Access Compliance Report

Public Rights-of-Way

Intersection ID: 53963	Main Street: MAGNOLIA_LILY_AV	Cross Street: LILAC_TREE_AV	Location:	N
ADA ID: F2EF78E60AE6	Ramp Type: BlendTrans1	Initial Pass/Fail: Fail	Overall Compliance: No	Severity Score: 21.25

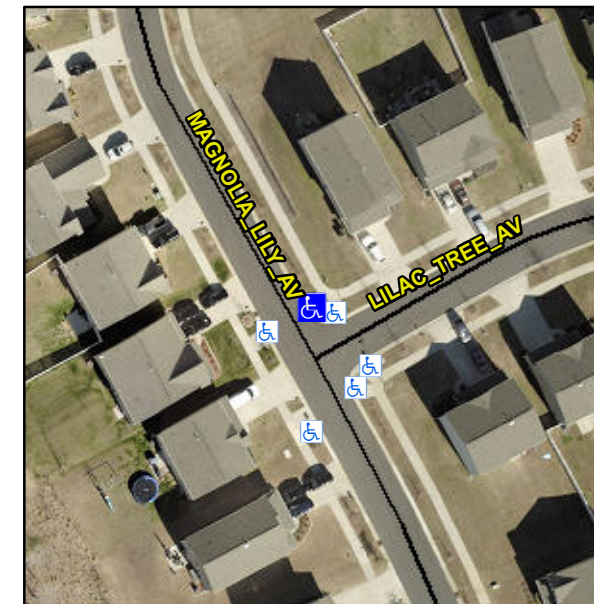
Not Found, R304.5.1, R304.5.3

Compliance	Description	Data	Compliance	Description	Data
N/A	Ramp Length (in)	128.0	Yes	BlendTrans Slope (%)	2.7
No	Ramp Width (in)	42.0	No	BlendTrans XSlope (%)	6.6
N/A	Flare Type LT	N/A	N/A	Flare Type RT	N/A
N/A	Flare Slope LT (%)	N/A	N/A	Flare Slope RT (%)	N/A
N/A	Flare Traversable LT?	N/A	N/A	Flare Traversable RT?	N/A
N/A	Landing Length (in)	N/A	N/A	DWS Provided?	N/A
N/A	Landing Width (in)	N/A	N/A	DWS Contrast?	N/A
N/A	Landing Slope (%)	N/A	N/A	DWS Length (in)	N/A
N/A	Landing X Slope (%)	N/A	N/A	DWS Full Width?	N/A
N/A	Landing Curb? (Y/N)	N/A	N/A	DWS Offset (in)	N/A
N/A	Shared Landing?	N/A			
N/A	Gutter Ponding?	N/A	N/A	Gutter Slope (%)	N/A
N/A	Gutter Lip Ht (in)	2.0	N/A	Gutter X Slope (%)	N/A
N/A	Painted X Walk1?	No	N/A	Painted X Walk2?	N/A
	X Walk 1 Direction	To SE		X Walk 2 Direction	N/A
	X Walk 1 Width (in)	N/A		X Walk 2 Width (in)	N/A
	X Walk 1 Slope (%)	4.5		X Walk 2 Slope (%)	N/A
	X Walk 1 X Slope (%)	3.0		X Walk 2 X Slope (%)	N/A

Remove & Replace Curb Ramp With Two New Directional Ramps or Equivalent.
